## **Demolition of a Structure within the South Rosedale Heritage Conservation District and Approval of a Replacement Structure - 12 Cluny Drive**

**Date:** January 4, 2022

**To:** Toronto Preservation Board

**From:** Senior Manager, Heritage Planning, Urban Design, City Planning

Proposed East (primary) Elevation of the proposed new house at 12 Cluny Drive.

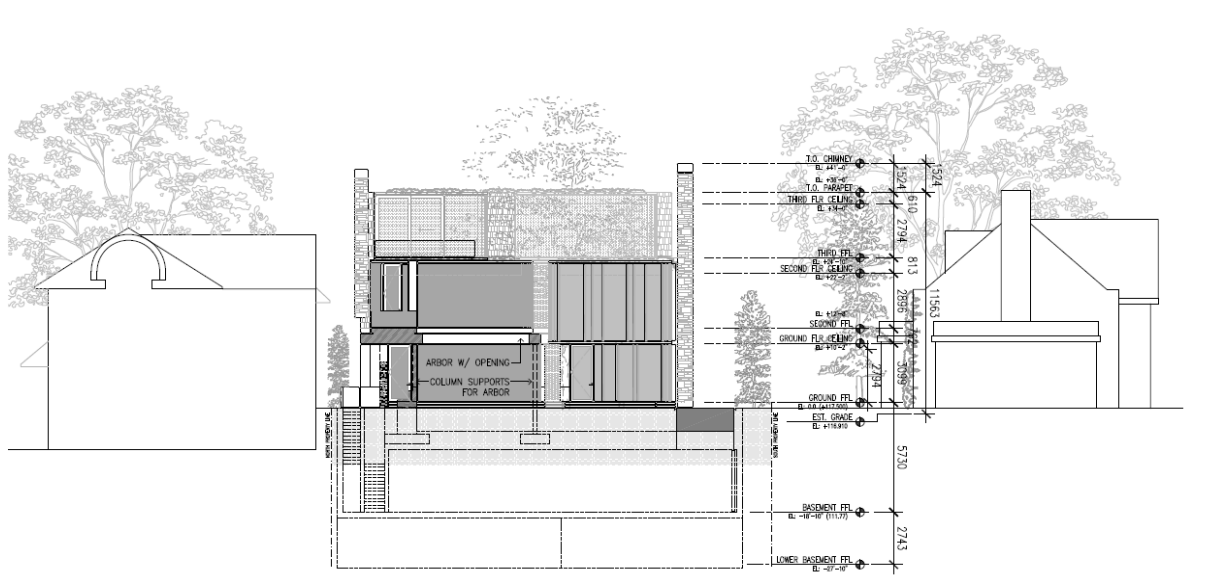
visual impact of the third storey. Following discussions with Heritage Planning staff, the applicant reduced the visual impact of the building by modulating the massing along the primary elevation and stepping back the third storey by approximately 5m above the second storey.

Proposed landscape plan of the property at 12 Cluny Drive, with the footprint of the existing house outlined in a dashed red line along with that of the proposed new house shaded grey. Partial footprints of adjacent houses are shown to compare front yard setbacks.

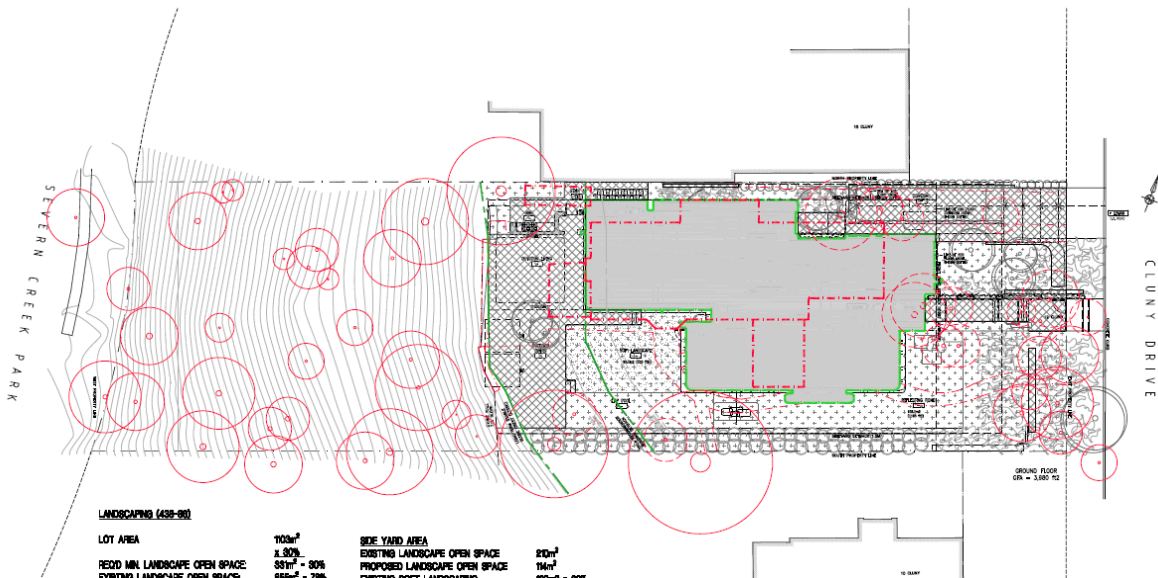
The design of the proposed new three storey house is by Harari Pontarini Architects. The existing front yard of the subject property is deeper than most of the properties along this side of Cluny Drive and although the proposed new building will be positioned closer to the street its front yard setback has been designed to transition between those of the two adjacent properties. In this way its setback is considered compatible within this part of Cluny Drive.

The proposal would remove some trees and vegetation from close to the existing house and include a large reflective pool within the front and side yards, however the pool will be positioned behind the existing landscaped road allowance. As such the visual impact from the public realm would be lessened and the "park-like" quality of this part of South Rosedale will be respected.
